Value Planning

Final Report

Elwha River Water Quality Mitigation Project 50-Percent Concept Development

November 14, 2000

Figure 9. State Fishery Reuse Plan

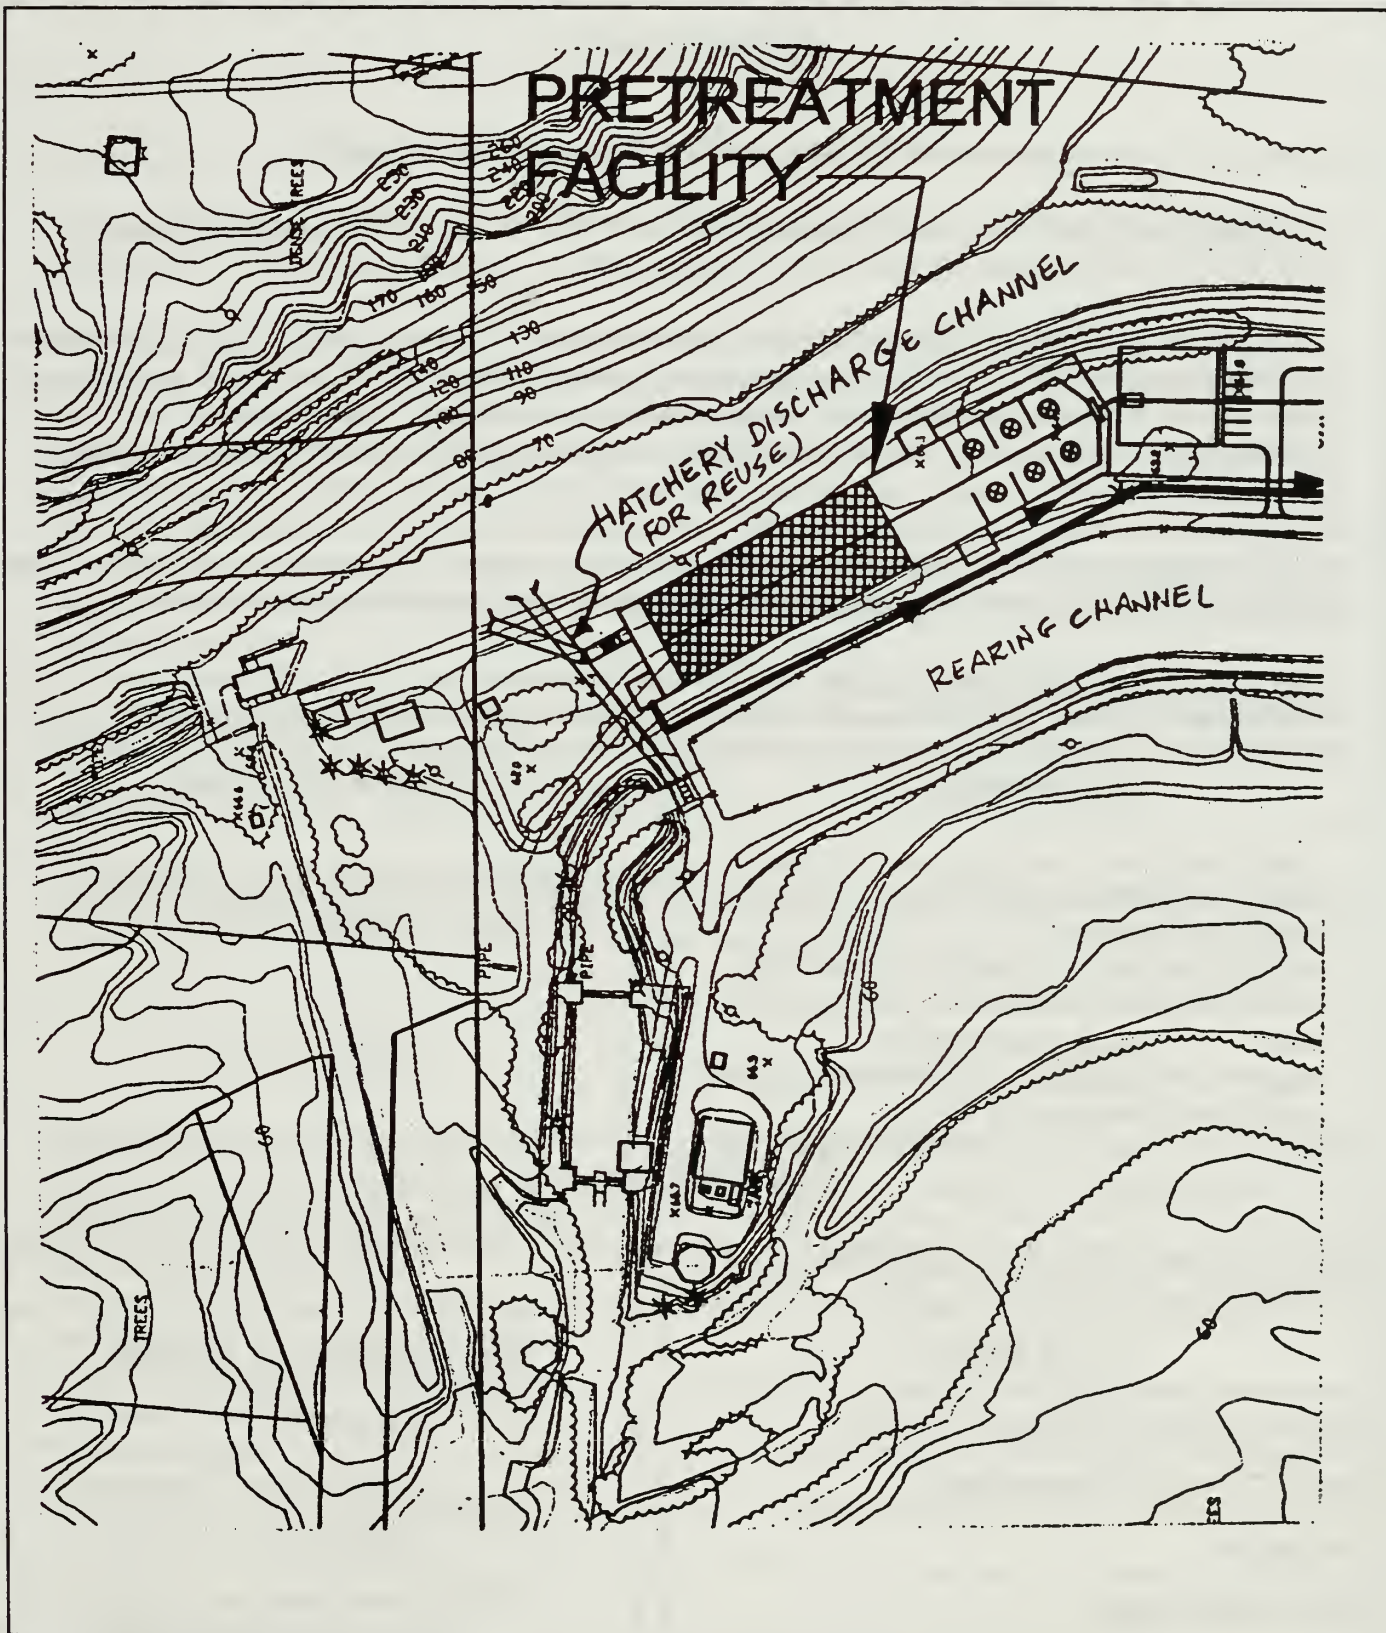
- Proposal Description: Divert a portion of the flow-through water from the fish hatchery to the Daishowa Mill. This diversion is anticipated only during periods of poor water quality in the river. This water would replace water from the Ranney wells in Concept Alternative 2.

- Critical Items to Consider: The design capacity for the State Hatchery is 33 cubic feet per second. This water, for the most part, is not consumptively used and is returned to the Elwha River. Therefore, it represents a considerable supply of water for other uses if it was captured and returned to the industrial supply line during peak sediment periods. It is assumed here that the release of attraction water would not be required during peak sediment flow periods. The Daishowa Mill would have to be willing to accept the fish hatchery water which may contain increased concentrations of ammonia and biological oxygen demand (BOD) from the fish food. The fish hatcheries have variable demands that are expected to be greater in the summer and lesser in the winter.

- Ways to Implement: A small crossover channel or pipeline would collect the discharge from the hatchery and return it to the industrial water pipeline. The system would be manually controlled. Implementation would be coordinated between the staffs at the hatchery and the mill.
